Access Compliance Report

Public Rights-of-Way

(Curb Ramps)

Intersection ID: 17113	Main Street: STERLING_RD	Cross Street: WESTFIELD_RD	Location: SW
ADA ID: 2CC091BB4AFB	Ramp Type: Directional1	Initial Pass/Fail: Fail	Overall Compliance: No
Severity Score: 13.75			
Codes/Mitigation Info/Possible Solution		Field Measurements/Component Compliance

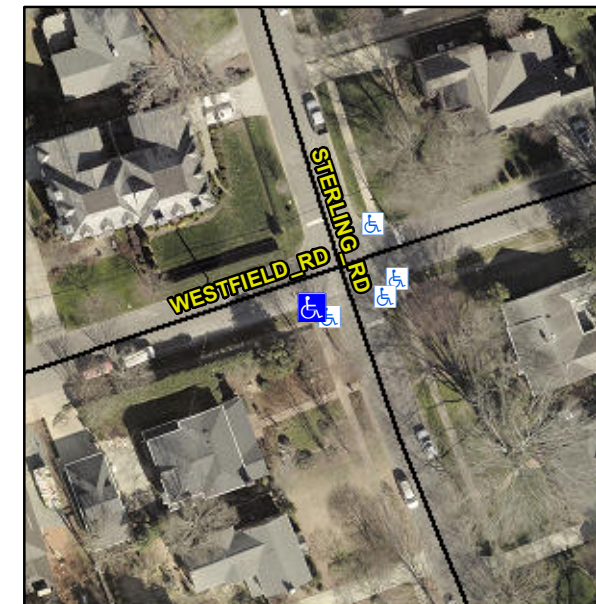
R304.2.2, R304.5.3

Compliance	Description	Data	Compliance	Description	Data
N/A	Ramp Length (in)	66.0	N/A	Grade Break?	N/A
Yes	Ramp Width (in)	48.0	N/A	Grade Break Slope (%)	0.0
No	Ramp Slope (%)	8.6	N/A	Grade Break XSlope (%)	0.0
No	Ramp XSlope (%)	4.1			
N/A	Flare Type LT	N/A	N/A	Flare Type RT	N/A
N/A	Flare Slope LT (%)	N/A	N/A	Flare Slope RT (%)	0.0
N/A	Flare Traversable LT?	N/A	N/A	Flare Traversable RT?	N/A
N/A	Landing Length (in)	0.0	N/A	DWS Provided?	N/A
N/A	Landing Width (in)	0.0	N/A	DWS Contrast?	N/A
N/A	Landing Slope (%)	0.0	N/A	DWS Length (in)	N/A
N/A	Landing X Slope (%)	0.0	N/A	DWS Full Width?	N/A
N/A	Landing Curb? (Y/N)	N/A	N/A	DWS Offset LT (in)	N/A
N/A	Shared Landing?	N/A	N/A	DWS Offset RT (in)	N/A
N/A	Gutter Ponding?	0.0	N/A	Gutter Slope (%)	N/A
N/A	Gutter Lip Ht (in)	0.0	N/A	Gutter X Slope (%)	N/A
N/A	Painted X Walk1?	No		Road Slope (%)	2.8
	X Walk 1 Direction	To NW		Road X Slope (%)	2.7
	X Walk 1 Width (in)	N/A		Clear Space?	N/A

Remove & Replace Entire Ramp.
